# SERVICE BULLETIN

Classification: EM16-001a	Reference: NTB16-007a	Date: March 22, 2016
------------------------------	--------------------------	-------------------------

## 2016 ALTIMA; VIBRATION FELT IN CENTER CONSOLE AND DRONING HEARD WHILE DRIVING

Figure 1

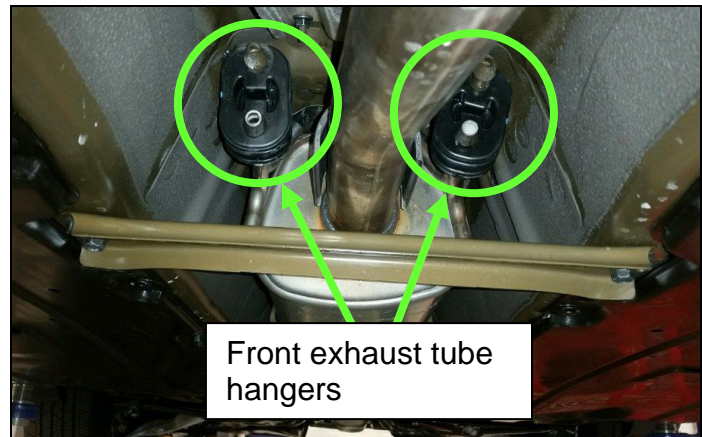
Remove two rubber “front exhaust tube hangers” shown in Figure 1 that support the rear of the center exhaust tube.

**IMPORTANT:** Vehicles built after the above Applied VIN and Date are no longer equipped with exhaust hangers installed in these locations.
